HEBRON PROJECT Comprehensive Study Report

Consolidated Comments

Combined Comments and Response Document

Figure 3-40 Speed Exceedance and Velocity Direction Distributions

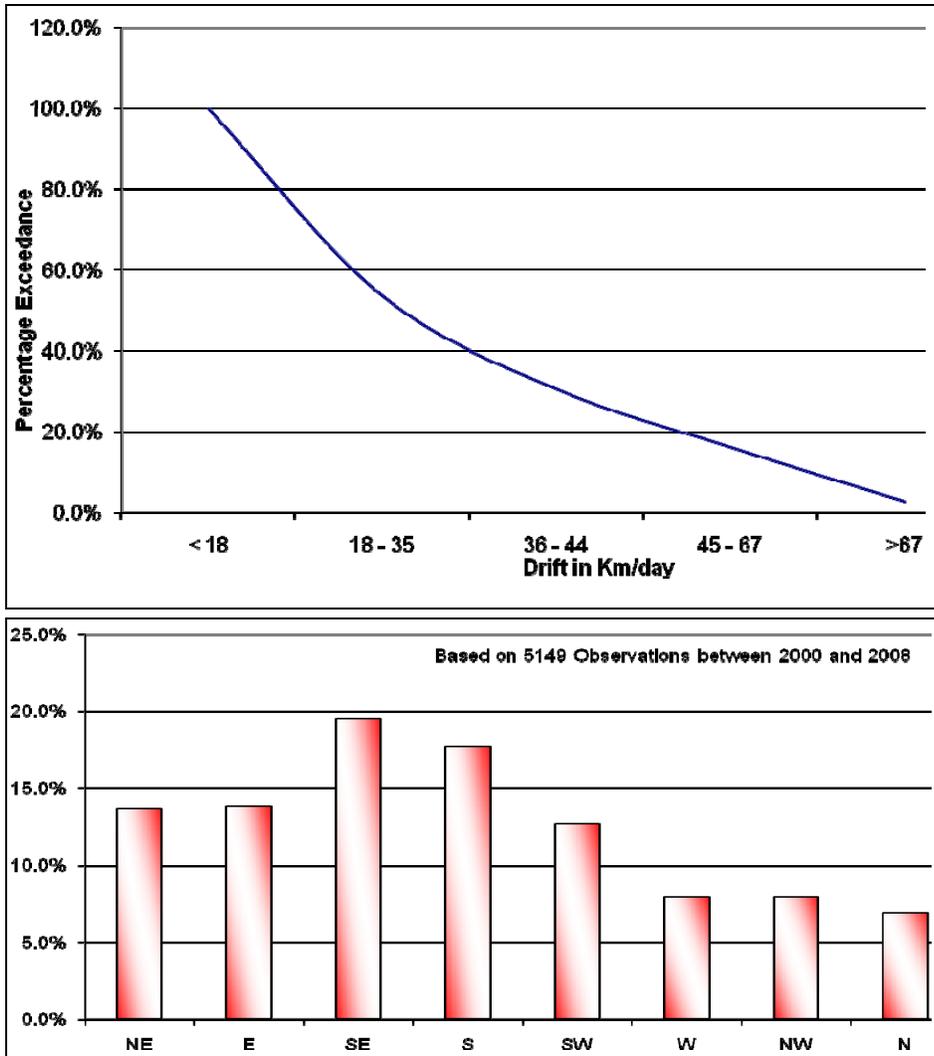
Comment A-39: *Figure 3-40: Errors ...*

- 1) The figure caption indicates that this figure shows data about both speed and direction. The text in paragraph 2 also refers the reader to Figure 3-40 for information on both of these factors. Yet the x-axes of both graphs shown in Figure 3-40 are identically labeled “Drift in km/day” and the ticks have speed values. Based on the similar Figure for ice drift (Figure 3-36) I suspect this is an error which needs to be corrected. **The second bar graph is supposed to show direction as opposed to speed, and its x-axis labels need to be corrected.**

EMCP Response 30-Nov-10: The figure will be edited as follows:
